UNITED STATES PATENT AND TRADEMARK OFFICE

APPLICATION NO.	FILING DATE	FIRST NAMED INVENTOR	ATTORNEY DOCKET NO.	CONFIRMATION NO.
10/734,104	12/11/2003	Martin Kamp	Nanoplus-2	1655
7265	7590	08/08/2006	EXAMINER	
MICHAELSON & ASSOCIATES			GOLUB, MARCIA A	
P.O. BOX 8489			ART UNIT	
RED BANK, NJ 07701			PAPER NUMBER	
			2828

Office Action Summary	Application No. 10/734,104	Applicant(s) KAMP ET AL.	
	Examiner Marcia A. Golub	Art Unit 2828

DETAILED ACTION

Fig 1c of '306 discloses a semiconductor laser comprising:

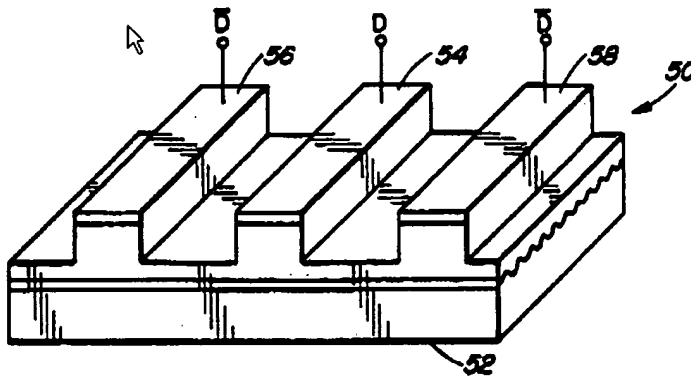
1. a semiconductor substrate [11];
a laser layer on said semiconductor substrate [13];
a waveguide ridge [15] located at a distance from said laser layer and
a first strip-shaped lattice structure [23] comprising alternating portions of conducting and non-conducting or less conducting material, wherein said lattice structure is located on the flat portions [20, 21] of the surface adjacent said ridge and at a distance from said laser layer [13] above said laser layer.

'306 does not disclose:

at least two waveguide ridges located at a distance from said laser layer whereby electrical injection into said laser layer is achieved through at least two of said waveguide ridges.

However, Fig 3 of '459 discloses a DFB laser with additional ridges [56, 58] positioned around the first ridge [54] and wherein the current is injected into the active

layer through all the ridges.

It would have been obvious to one of ordinary skill in the art at the time of the invention to incorporate the teachings of '459 into the device of '306 by adding and additional ridges around the central ridge and the first lattice structure to the DFB laser structure for at least the purpose of reducing thermally-induced emission wavelength shift in the laser.
